SERVICE BULLETIN SB1266

ADDRESSEES	: Owners and operators of coaches listed under 'Application'	
VEHICLE MODEL	: TX40-TX45	
SYSTEM/SUBSYSTEM	: 9.6 Occupant protection systems – Driver seat belt	
BULLETIN TYPE	: Safety Recall NHTSA 14V-304	
DATE	: September 05th, 2014	
SUBJECT	: Driver seat belt assembly – To modify attachment to B-pillar	
TERMS & CONDITIONS	: Refer to the warranty section further in this Bulletin.

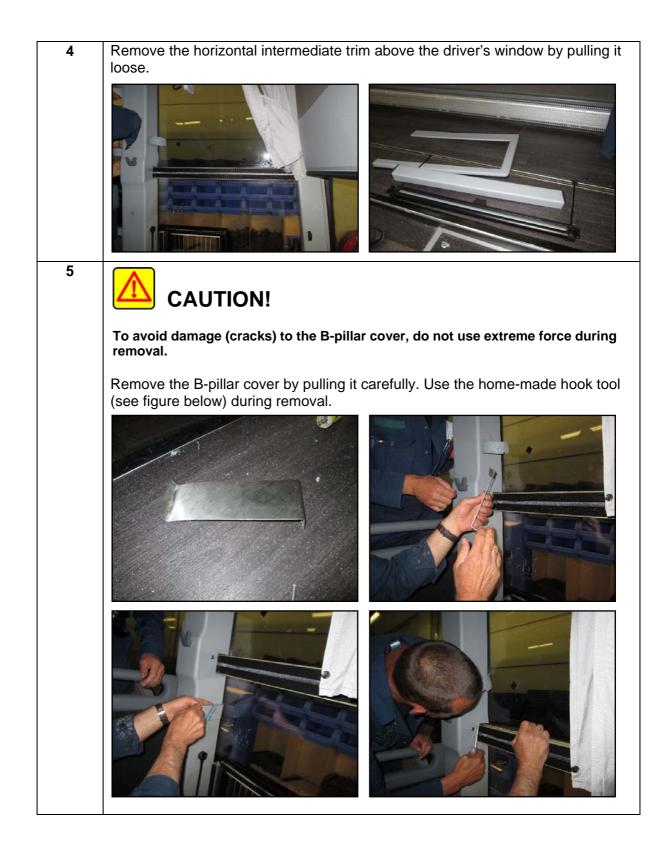
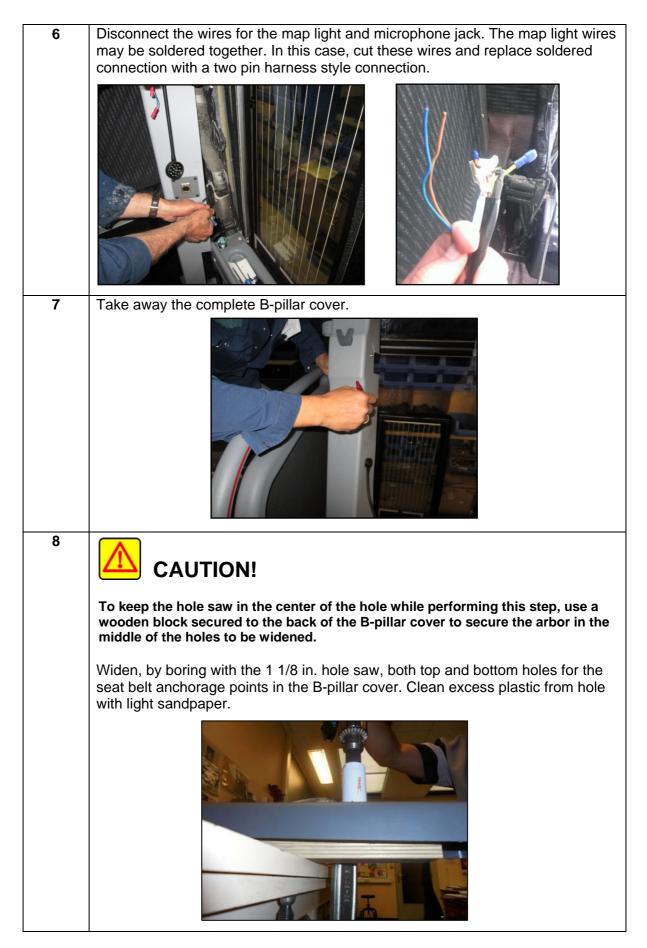
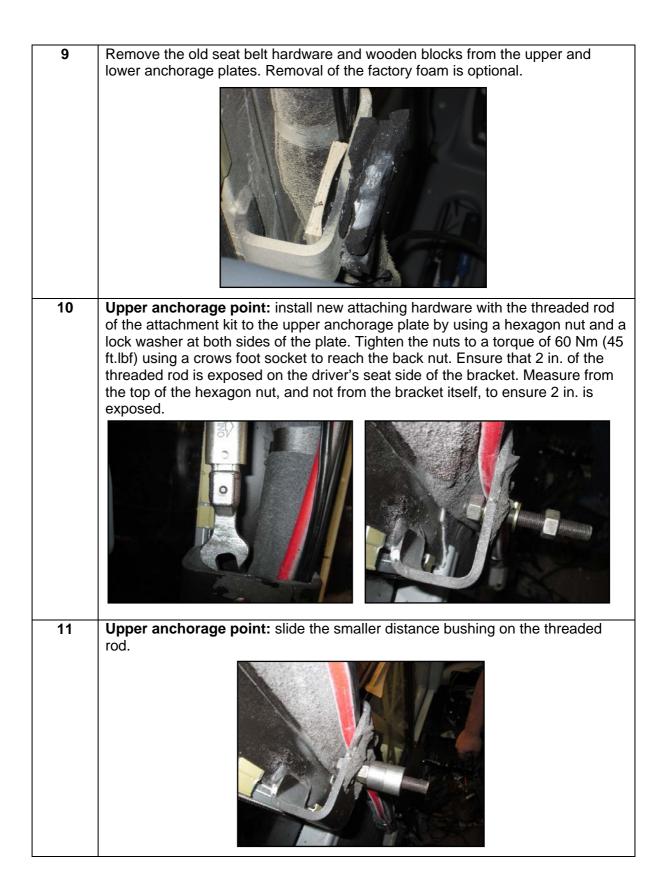
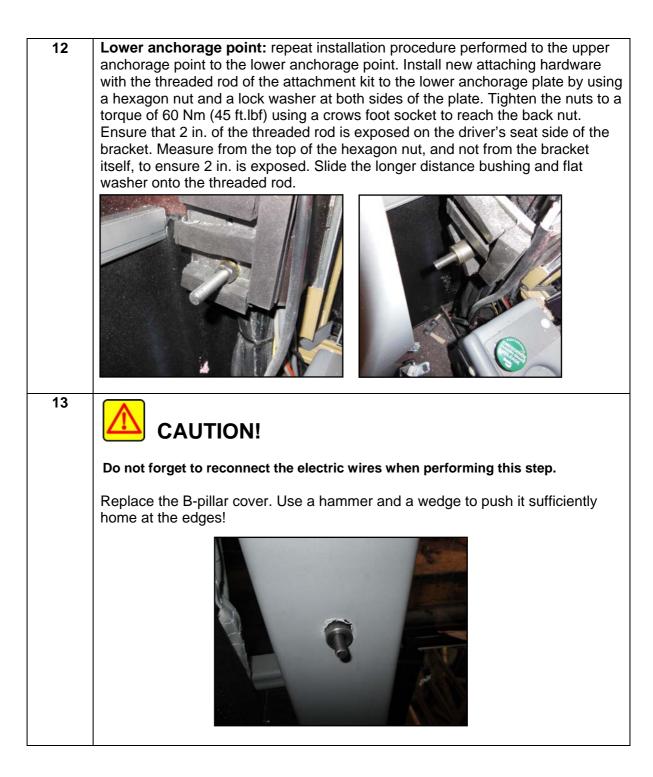
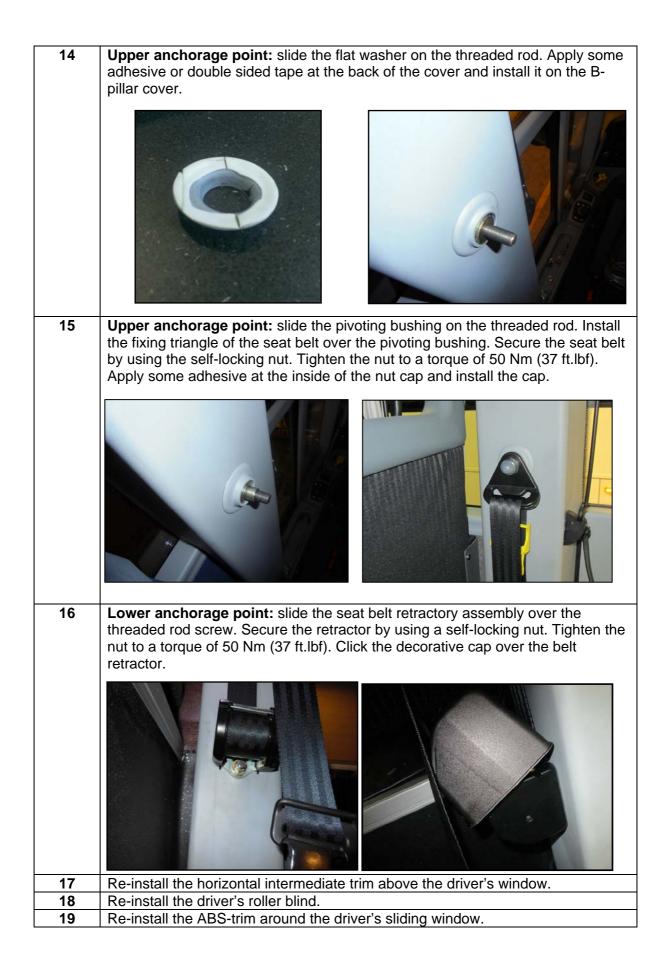
- 1. Van Hool has determined that the driver seat belt assembly may not be properly secured to the B-pillar anchorage on the vehicles listed above. The cap screws securing the driver seat belt to the anchorage points on the B-pillar may come loose.
- 2. On the vehicles listed above, it is necessary to modify the attachment of the driver seat belt to the anchorage points on the B-pillar. This modification will properly secure the driver seat belt to the B-pillar. For this purpose, a new attachment kit has been made available. Refer to the procedure in this Service bulletin for fitting instructions. The terms and conditions of the campaign have been detailed in the warranty section.

Step	Action
1	Remove the driver seat belt at its upper and lower anchorage points on the B- pillar.
2	Remove the trim around the driver's sliding window by pulling it loose.
3	Remove the driver's roller blind.
	<image/>
